SERVICE BULLETIN

SB04-4A

**SUBJECT: REPLACEMENT OF MANIFOLD VALVE
SPRING P/N 630184**

**ENGINES
AFFECTED:** IO-240-B Series Engines.

FIGURE 1
MANIFOLD VALVE EXPANDED VIEW

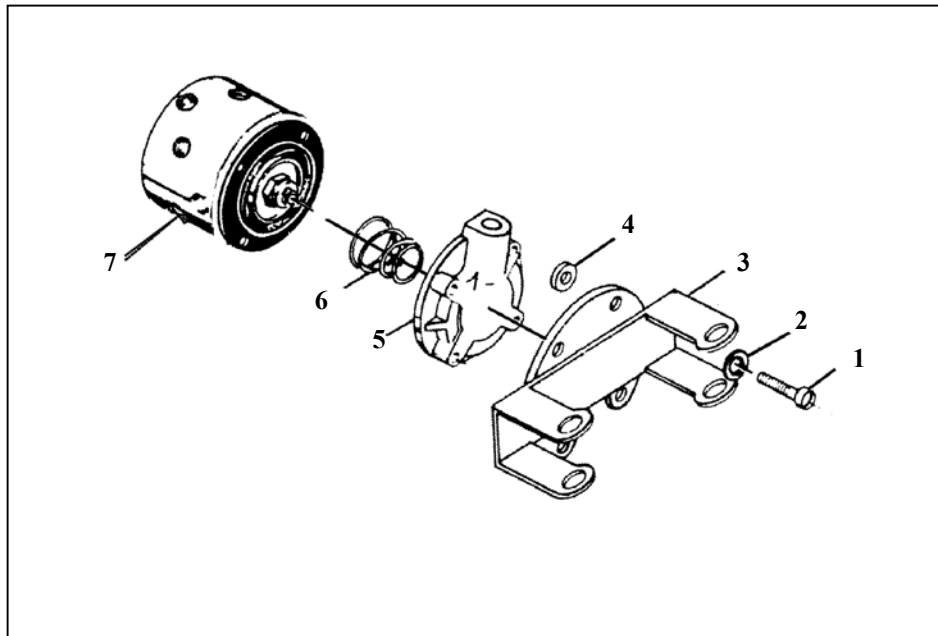
PURPOSE: To provide instructions for the replacement of manifold valve spring P/N 630184 with spring P/N 627378.

16. Remove manifold valve spring P/N 630184, one coil dyed green, which is positioned between the manifold valve diaphragm and plunger assembly and the manifold valve cover.

17. Install manifold valve spring P/N 627378, which does not have a color coded coil, with the large diameter of the spring against the manifold valve diaphragm retainer.

19. Torque manifold valve cover screws to 24 inch pound \pm 2 inch pounds. Safety wire the screws in pairs.
20. Re-install the manifold valve and bracket on the engine using the two bolts, washers and nuts. Torque the backbone bolt and nut to 100 to 125 inch pounds.
21. Remove protective plugs and caps, installed in step 4 above, as each system line or hose is reattached.
22. Re-install the fuel injection lines to the manifold valve. Do not torque at this time.
23. Re-install the fuel injection lines to the four fuel injection nozzles in each cylinder. Ensure fuel injection nozzle lines are correctly routed and supported. Torque each fuel injection nozzle line “B” nut at nozzles to 40 to 45 inch pounds.
